**CERTIFICATE OF APPROPRIATENESS**

**Property:** 716 Arlington Street, Lot 17, Block 257, Houston Heights Subdivision. The property includes a historic 1,387 square foot, one-story wood frame single-family residence and a detached shed situated on a 6,600 square foot (50' x 132') interior lot.

**Proposal:** Alteration – Construct a 1,374 square foot one and a half story addition and attached garage at the original rear wall of the residence.

**EAST (REAR) ELEVATION**

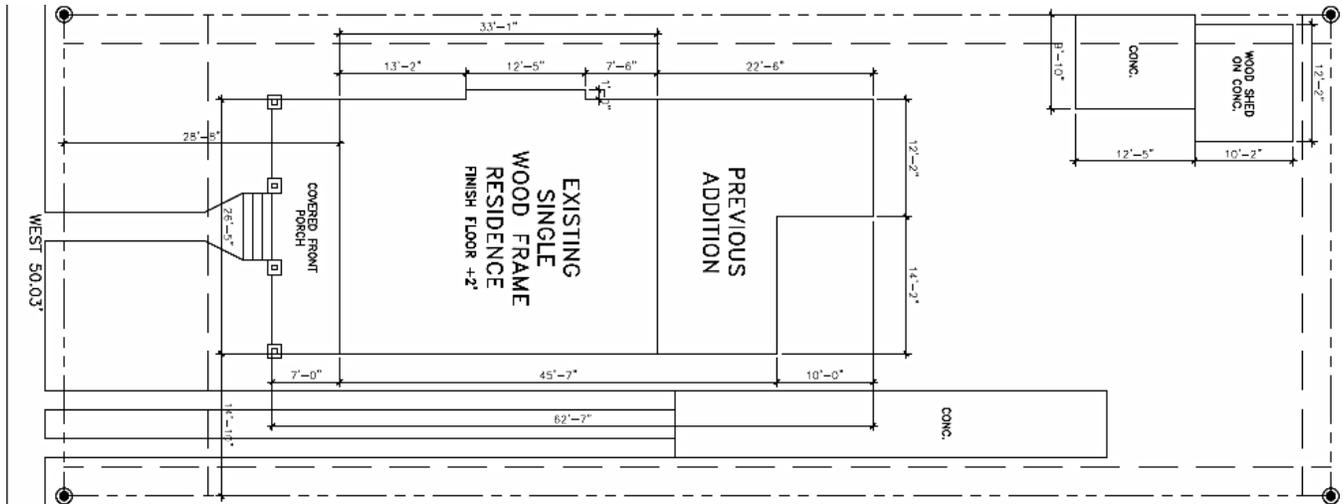
I can SUPPORT WITH CONDITIONS, the proposed one-story addition to the rear of the existing contributing structure. Two proposed modifications warrant additional conditions. First, the applicant proposes to elevate the existing structure an additional 6 inches to a total of 30 inches above natural ground. To accomplish the elevation change, the brick/wood combination columns will need adjustment. I can support this change being accomplished by a foundation addition to the bottom of the exiting brick base that would raise the brick/wood combination column along with the remainder of the house structure so that the front vertical proportion of the elevation would remain constant. The vertical addition at the bottom of the combination columns would have the least negative visual impact when compared to other methods of raising the house structure and not raising the combination columns or adding to the wood portion of the column to increase the height.

Second, the applicant proposes to add side dormers to the addition for additional natural lighting. The visual character of these proposed dormers completes with the simplistic visual character of the existing contributing structure and visually enhances the proposed addition to the detriment of the existing historic structure. I can support this application if the visual impact of the proposed side dormers is reduced.
